MEMORANDUM

Re: Library Redevelopment Value Engineering Study

**Value Engineering
Alternative Proposals**

February 18, 2022
Our Ref: 30115878
Takoma Park Library Replacement
Value Engineering Study Results

Proposed location of the geothermal wells

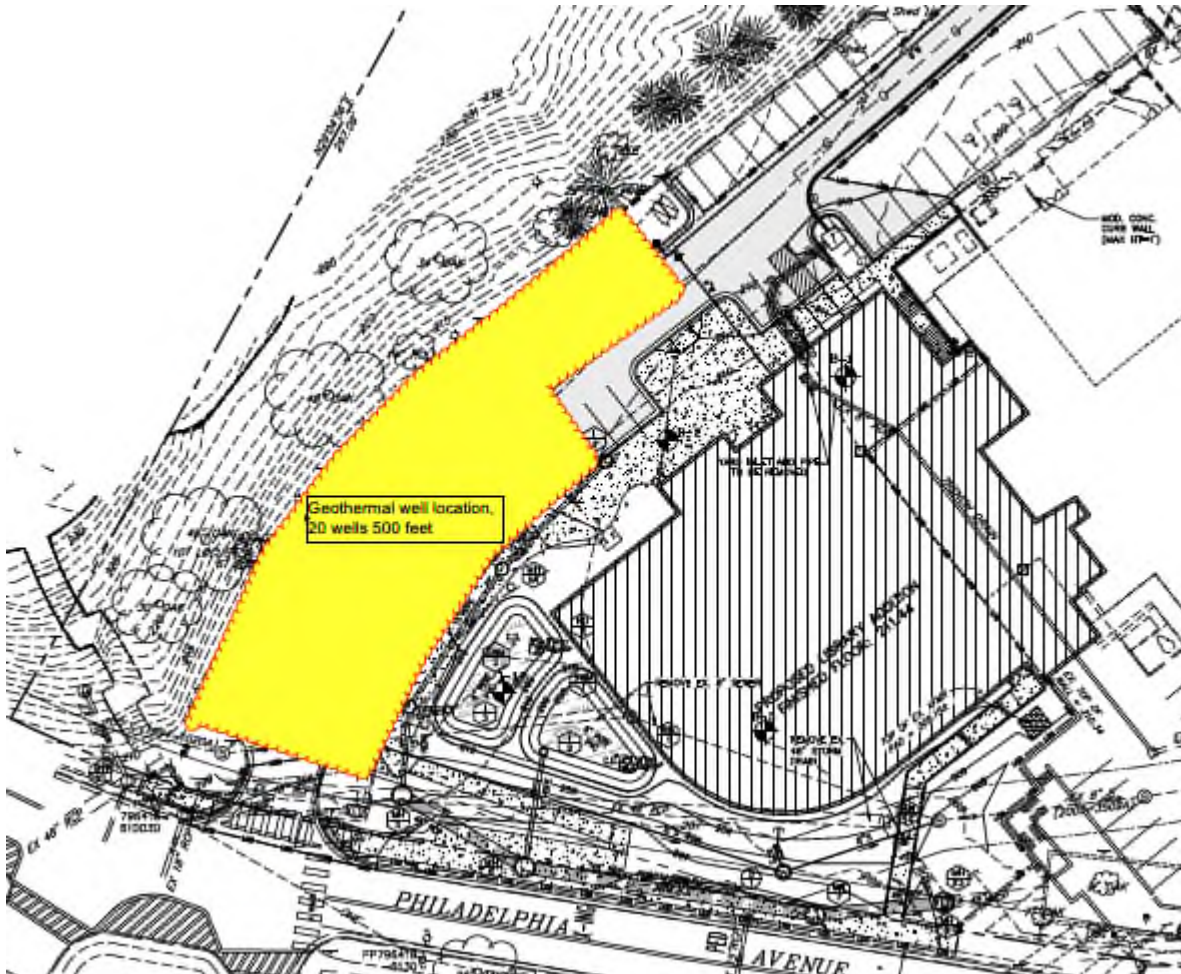
An alternative approach to an air-air refrigerant cycle is to use a geothermal heat sink. To meet demands, roughly 20 wells approximately 500 feet deep would be needed. The parking lot would be a good location for the wells.

Utilizing geothermal along with reducing the window glazing from triple to double, as well as roofing thickness, could impact the total cost analysis. Implementation would require a redesign of the heating, ventilating and air conditioning system and a rerun of the energy model to confirm the ability to reduce building envelope.

ALTERNATIVE SKETCH

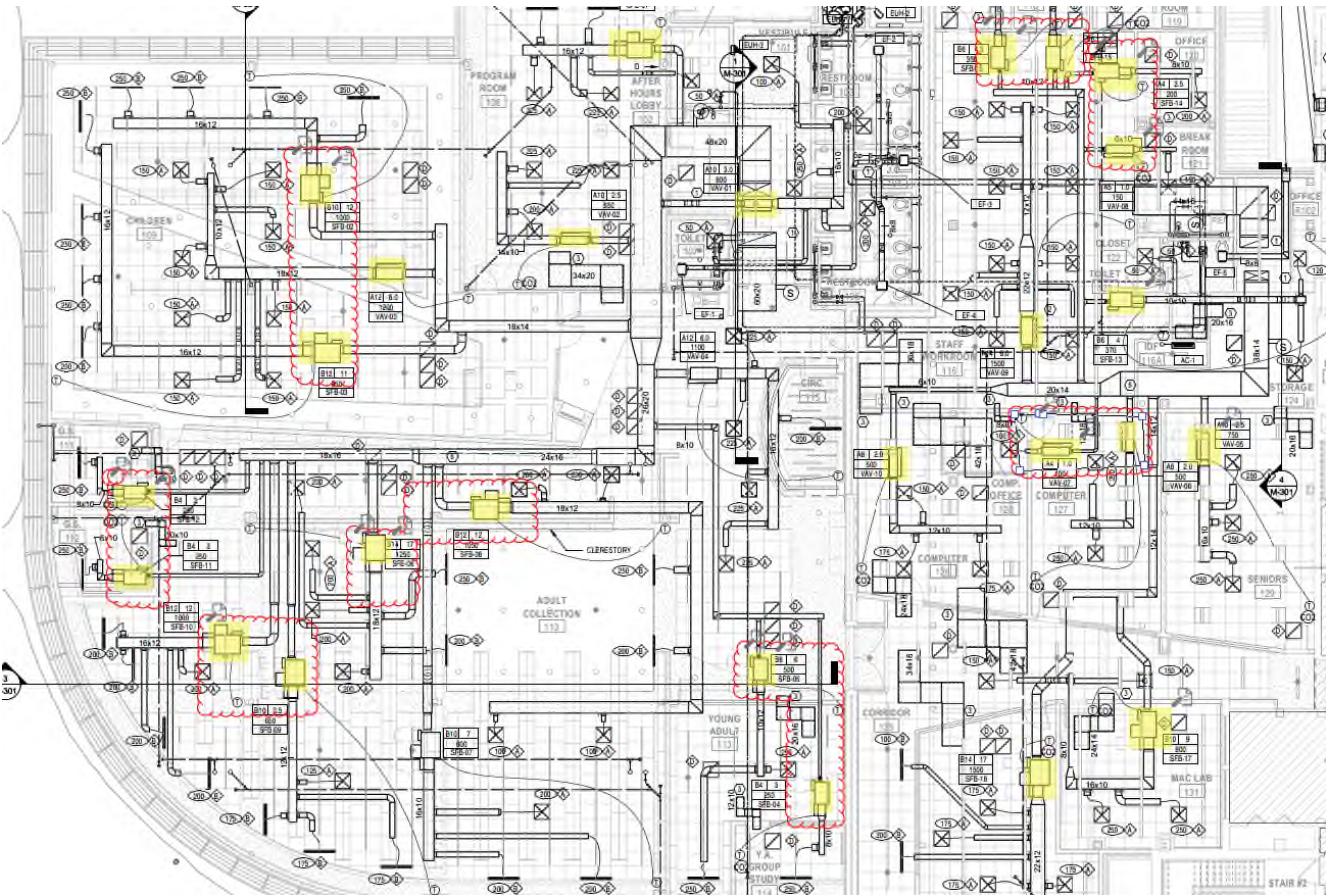
- Reduces temperature control zones
- 5. Discussion:** In reviewing drawing M-102, we see several zones that could be combined, limiting the number of air terminal units. Proposed design optimizes the HVAC system in operations as well as in construction.

Below is a section of M-102 showing the air terminal units (VAV/SFB) locations. Areas clouded in red should be considered for combining the zones and eliminating one of the terminal boxes.

REVISE EXTERIOR WALL AT OFFICE AND CONFERENCE ROOM – (ROOMS 117/118/119)

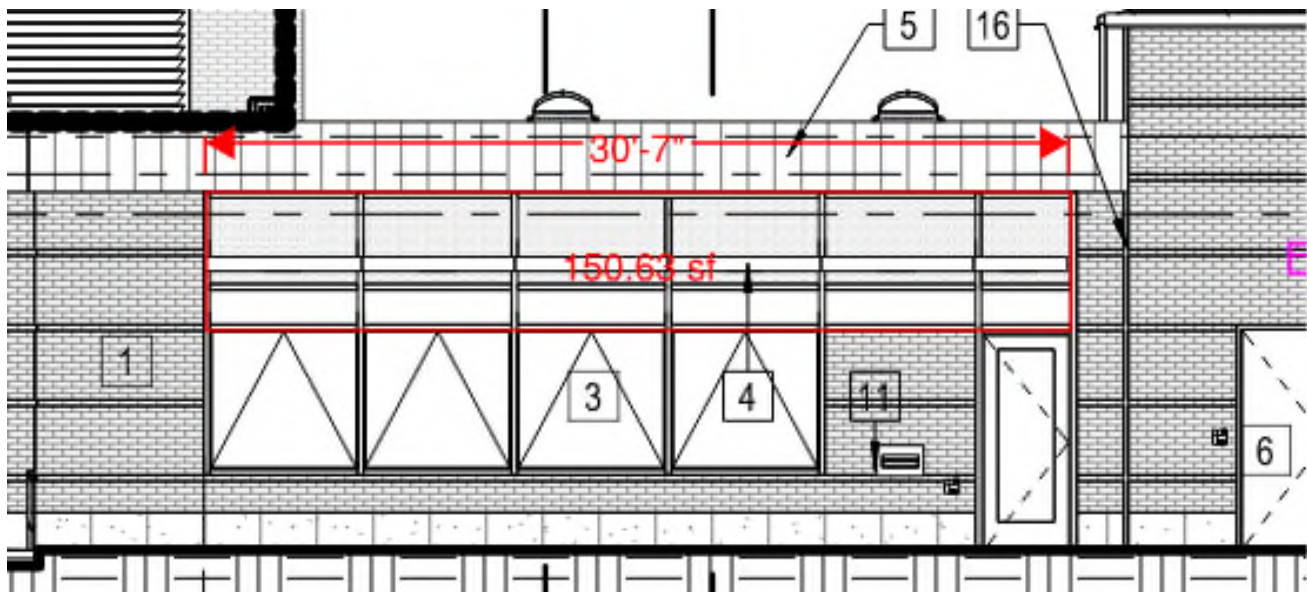
1. **Description of Baseline Concept:** Windows on the north elevation in the Receiving, Office and Conference Rooms have a spandrel section and window shade. See sketch on following page.
2. **Description of Alternative Concept:** Eliminate the upper section of windows and associated sunshade and replace with brick veneer.

CE-7	Revise exterior wall at office and conference room (Rooms 117/118/119)	\$38,000	\$9,000	\$29,000	\$12,500	Study suggests deleting the upper two rows of glass as well as deleting the sunshade. I would support this change as it would still get natural light into the areas and the sunshade is mostly decoration at this location because the windows are north facing	YES	\$1,500 GPI \$1,500 RRMM	Yes	1-2 Months
CE-8	Revise exterior wall at lounge area (Room 130)	\$21,000	\$5,000	\$16,000	\$13,000	Study suggests deleting the upper row of glass and the sunshade. Im fine with this as the upper row of glass is all spandrel anyway.	YES	\$1,500 GPI \$1,500 RRMM	Yes	1-2 Months

REVISE EXTERIOR WALL AT LOUNGE AREA – (ROOM 130)

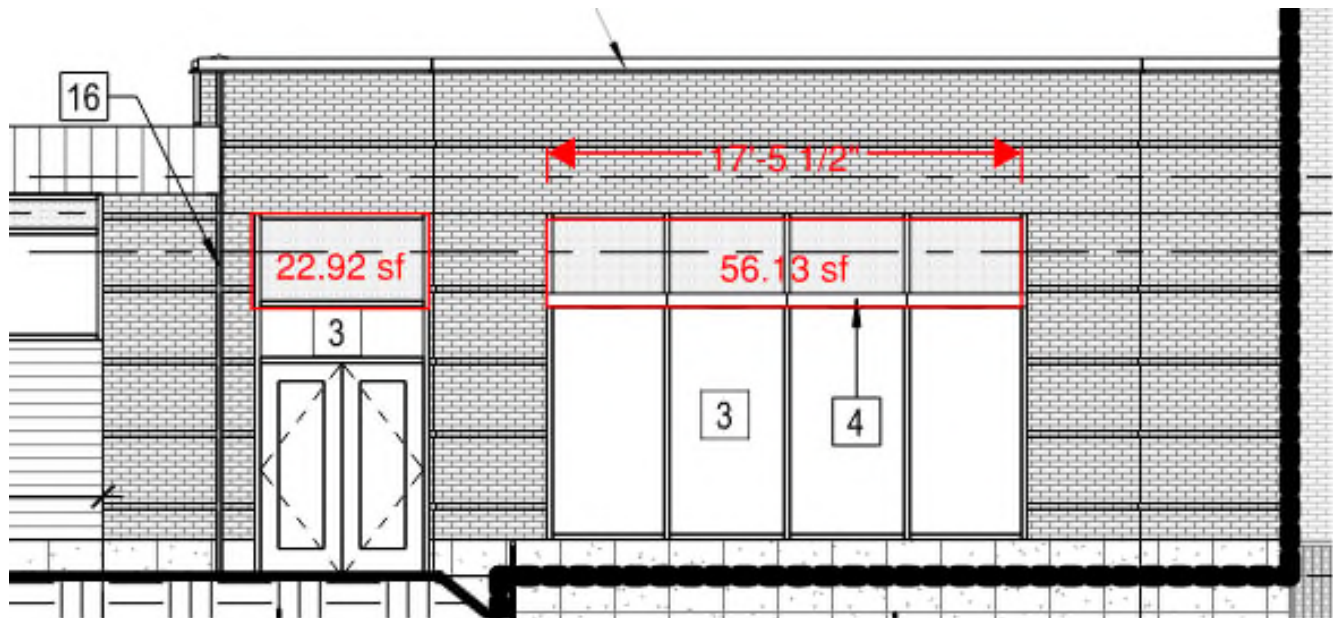
2. **Description of Alternative Concept:** Eliminate the upper section of windows and associated sunshade and replace with brick veneer.
3. **Advantages:**
 - Cost savings
 - Increases thermal insulation on exterior wall
4. **Disadvantages:**
 - Window line is not maintained over entire elevation
5. **Discussion:** Cost savings may be realized by the reduction of curtainwall and sunshade. The increased thermal insulation may reduce HVAC load. While the window line is not maintained over the entire elevation, the isolated nature of the window will have limited effect on the aesthetics.
6. **Discussion of Schedule Impacts:** No negative impact on construction schedule.
7. **Discussion of Risk Impacts:** None identified.
8. **Discussion of Operating Impacts:** No operating impacts expected.

SKETCHES

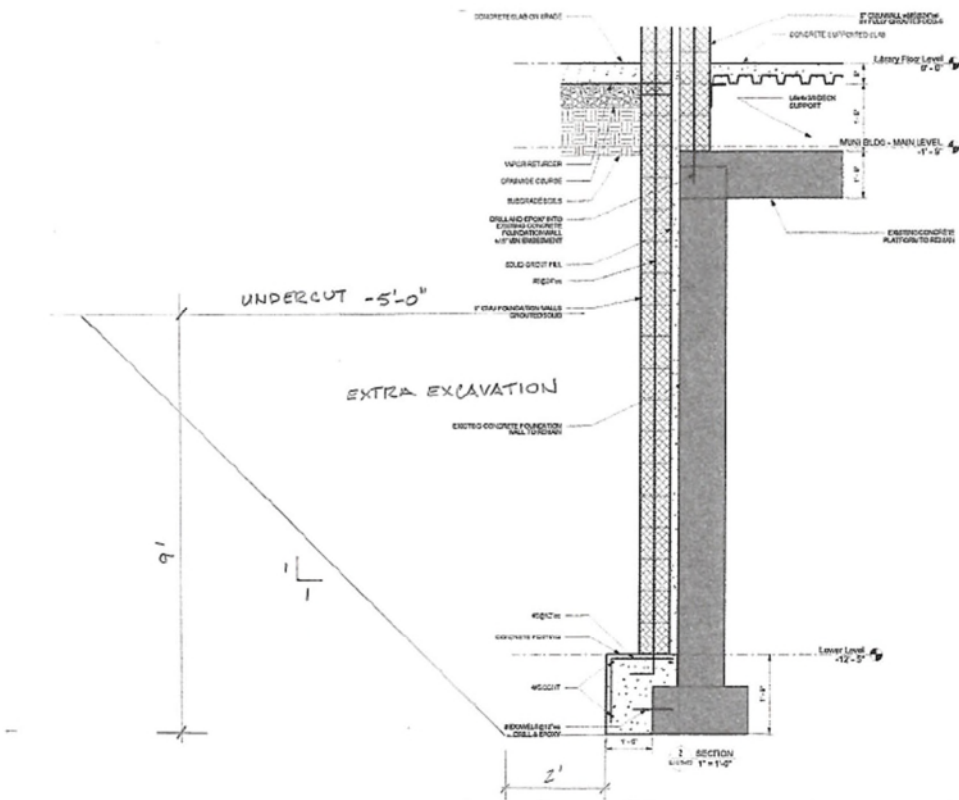
- Discussion:** By not having to construct the lower portion of the new masonry wall the contractor will no longer need to excavate down to the lower-level footing. This avoids having to stockpile the excavated material and then replace it, saving time and costs. For this to be implemented the designer has to verify that the existing concrete wall is capable of accepting the new masonry wall.

EXTRA MASONRY
 $9 \times 124 = 1116 \text{ SF}$

INSERT A SLEEVE BETWEEN THE 8-INCH SANITARY SEWER AND 24-INCH STORM SEWER TO ACCEPT THE NEW WATER LINE IN LIEU OF DIGGING A DEEP HOLE TO RUN THE WATER LINE UNDER THE SANITARY SEWER LINE

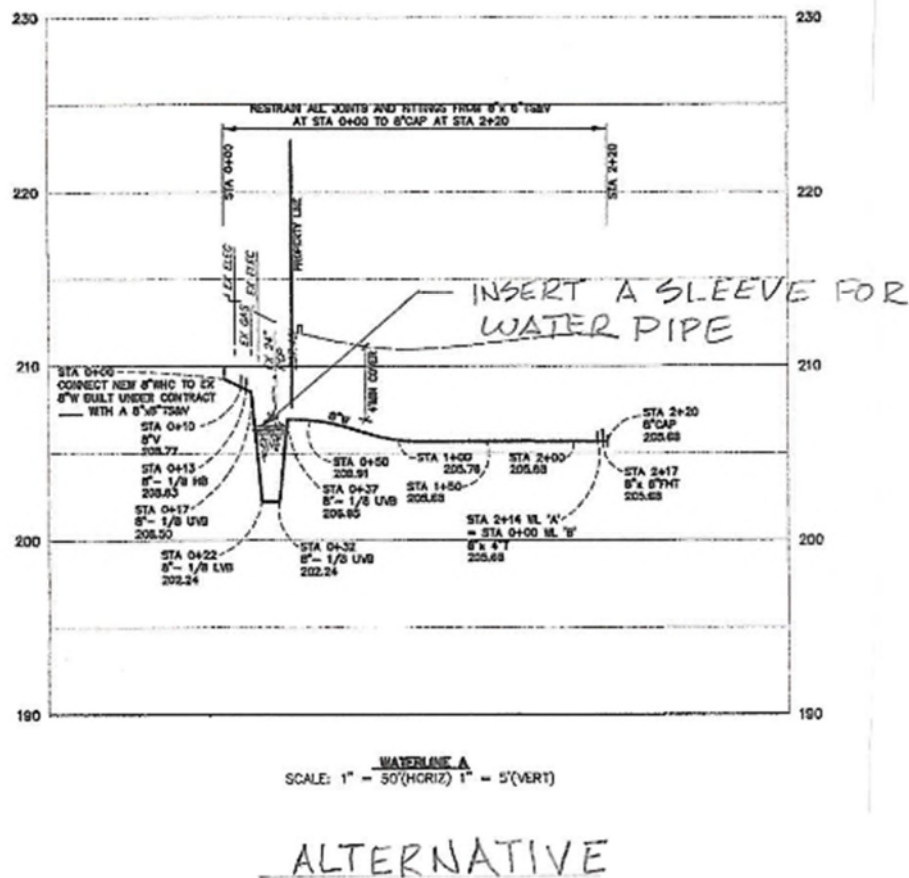
- 2. Description of Alternative Concept:** Jack a 10- or 12-inch diameter steel pipe sleeve under the 24-inch stormwater line and place the water line in the sleeve in lieu of digging the deep hole.

RETAIN THE RECREATION AREA AS IS AND MAKE IT A CONSTRUCTION CONTRACT ADD ALTERNATE

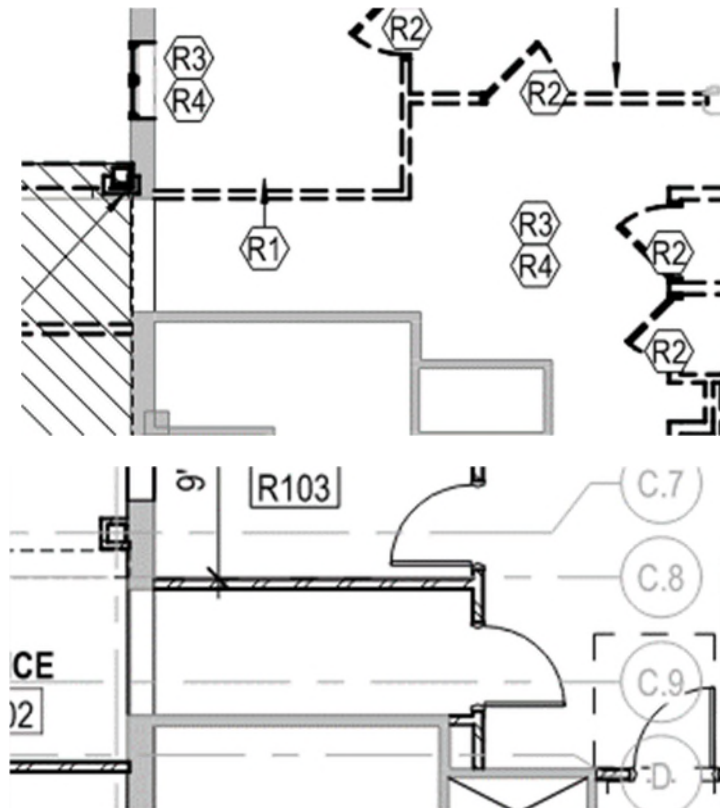
1. **Description of Baseline Concept:** The baseline concept renovates the Recreation Area to provide new restrooms and office area.

2. **Description of Alternative Concept:** Include the Recreation Area renovation as an add alternate in the construction contract. Build out the storage room only to prevent a dead-end corridor.
3. **Advantages:**
- Cost savings – Adds back into project if budget allows
 - Prevent base bids from exceeding the budget
4. **Disadvantages:**
- Budget may not allow renovation
5. **Discussion:** In order to prevent base bids from exceeding the budget, include the renovation of the Recreation Area as an add alternate to the construction contract. Build out the storage room in the office area to eliminate the dead-end corridor. If the bids received have a separate bid amount for the renovation that exceeds the budget, the scope of the renovation can be reevaluated to fit into the remaining budget.

PHASING										
PH-1	Retain the Recreation Area as is and make it a construction contract Add Alternate	\$1,202,000	\$4,000	\$1,198,000	\$1,178,000	Value judgement by the Library / City. Dead end corridor issue can be solved by creating a loop as discussed with Brandon. Real \$ is in bathrooms. Doesn't have any effect on energy. Eliminates gender neutral restrooms.	MAYBE - DECISION BY LIBRARY / CITY	\$ 20,000.00	Yes	3-4 Months
PH-2	Retain the Recreation Area as is except for the office areas and include in the construction contract as an Add Alternate	\$1,202,000	\$526,000	\$676,000	\$666,000	This scheme the office area would be included in the base bid as designed but the restroom becomes an add alternate. In this case, we would have to determine if there is a way to maintain access the existing restrooms. Otherwise they may become inaccessible to the public which would affect fixture counts. Same comments as above.	MAYBE - DECISION BY LIBRARY / CITY	\$ 10,000.00	Yes	3-4 Months

RETAIN THE RECREATION AREA AS IS EXCEPT FOR THE OFFICE AREAS AND INCLUDE IN THE CONSTRUCTION CONTRACT AS AN ADD ALTERNATE

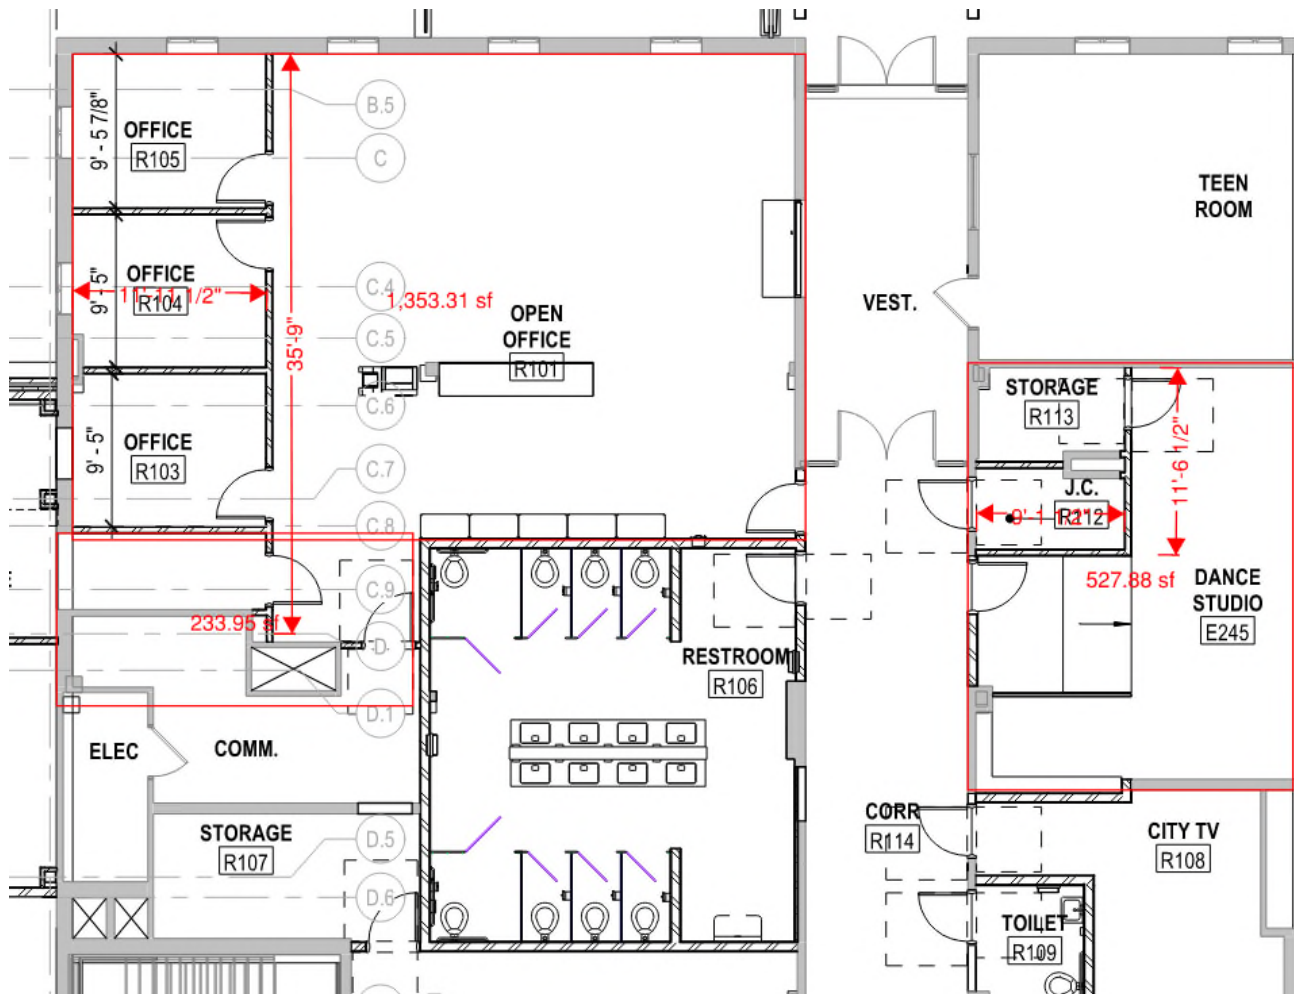
- Description of Baseline Concept:** The baseline concept includes the renovation of the Recreation Area to provide new restrooms and office area.

- Description of Alternative Concept:** Include the restroom renovation as an add alternate in the construction contract and build out the Recreation Area Office and Dance Studio Areas.

5. Discussion: To prevent base bids from exceeding the budget, include the renovation of the Recreation Area restrooms as an add alternate and build out the Office Area and Dance Studio. If the bids received have a separate bid amount for the renovation that exceeds the budget, the scope of the renovation can be reevaluated to fit into the remaining budget.

DO NOT BUILD OUT COMPUTER, SENIOR, LOUNGE, AND MAC ROOMS AND MAKE THESE AREAS A CONSTRUCTION CONTRACT ADD ALTERNATE

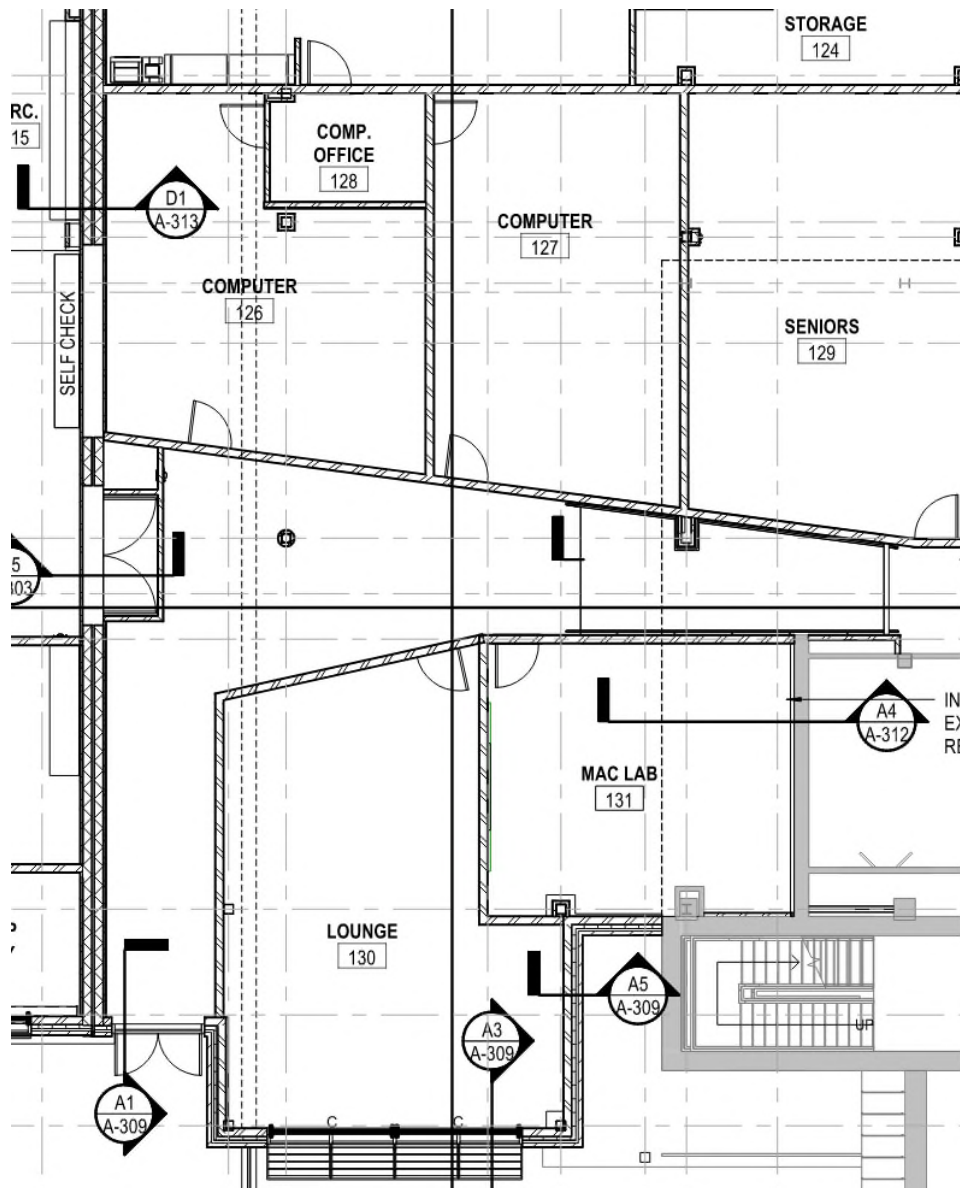
- Description of Alternative Concept:** Leave the Computer Rooms, Senior Room, Lounge and Mac Room as shell space. Do not construct interior walls, finishes, electric, and data system. Make this work an Add Alternate in the construction contract.

5. **Discussion:** In order to prevent base bids from exceeding the budget, leave the Computer Rooms, Senior Room, Lounge, and Mach Room (Rooms 126, 127, 128, 129, 130, & 131) as shell space. Do not provide interior walls, finishes, electric and data systems. Continue to provide sprinkler, fire alarm, and HVAC systems. The corridor remains fully built-out. If this work is not chosen as an add alternate, temporary provisions for fire alarm, sprinkler heads, and lighting will be required for the permit. The cost of the temporary items will be lost when the space build-out is complete.

PH-3	Do not build out Computer, Senior, Lounge and MAC rooms and make these areas a construction contract Add Alternate	\$141,000	\$0	\$141,000	\$135,000	Shell space only. Value judgement by the library and the city. Can they live without these spaces	MAYBE - DECISION BY LIBRARY	\$ 6,000.00	Yes	1-2 Months
PH-4	Do not build stand-alone canopy	\$48,000	\$0	\$48,000	\$46,000	Quite possible if they are OK with losing the shelter aspect of the canopy	MAYBE - DECISION BY LIBRARY / CITY	\$ 2,000.00	Yes	1 Month
